Access Compliance Report

Public Rights-of-Way

(Curb Ramps)

Intersection ID: 14833	Main Street: ALBEMARLE_RD	Cross Street: MARTIN_LAKE_RD	Location: NE
ADA ID: 857209D4C6AA	Ramp Type: PerpDiag	Initial Pass/Fail: Fail	Overall Compliance: No
Severity Score: 8.75			
Codes/Mitigation Info/Possible Solution		Field Measurements/Component Compliance

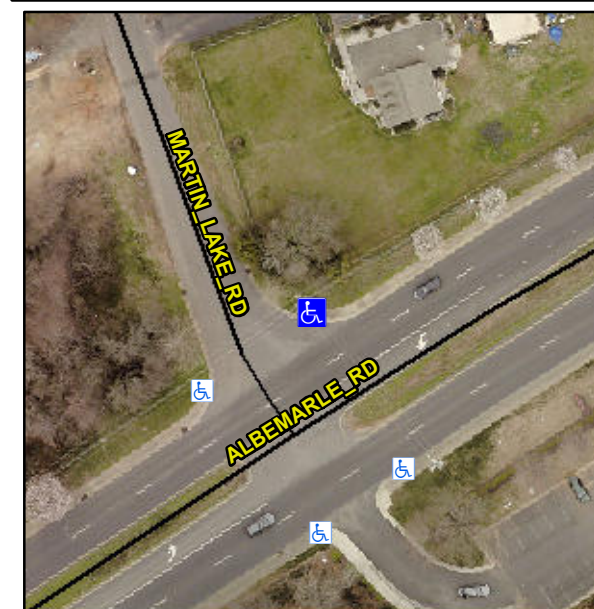
Not Found, R304.5.1

Compliance	Description	Data	Compliance	Description	Data
N/A	Ramp Length (in)	60.0	Yes	Ramp Slope (%)	8.0
No	Ramp Width (in)	42.0	Yes	Ramp XSlope (%)	2.0
N/A	Flare Type LT	N/A	N/A	Flare Type RT	N/A
N/A	Flare Slope LT (%)	N/A	N/A	Flare Slope RT (%)	N/A
N/A	Flare Traversable LT?	N/A	N/A	Flare Traversable RT?	N/A
N/A	Landing Length (in)	N/A	N/A	DWS Provided?	N/A
N/A	Landing Width (in)	N/A	N/A	DWS Contrast?	N/A
N/A	Landing Slope (%)	N/A	N/A	DWS Length (in)	N/A
N/A	Landing X Slope (%)	N/A	N/A	DWS Full Width?	N/A
N/A	Landing Curb? (Y/N)	N/A	N/A	DWS Offset (in)	N/A
N/A	Shared Landing?	N/A			
N/A	Gutter Ponding?	N/A	N/A	Gutter Slope (%)	N/A
N/A	Gutter Lip Ht (in)	N/A	N/A	Gutter X Slope (%)	N/A
N/A	Painted X Walk1?	No	N/A	Painted X Walk2?	No
	X Walk 1 Direction	To SW		X Walk 2 Direction	To S
N/A	X Walk 1 Width (in)	N/A	N/A	X Walk 2 Width (in)	N/A
	X Walk 1 Slope (%)	1.6		X Walk 2 Slope (%)	2.3
	X Walk 1 X Slope (%)	3.9		X Walk 2 X Slope (%)	0.4

Remove & Replace Curb Ramp With Two New Directional Ramps or Equivalent.
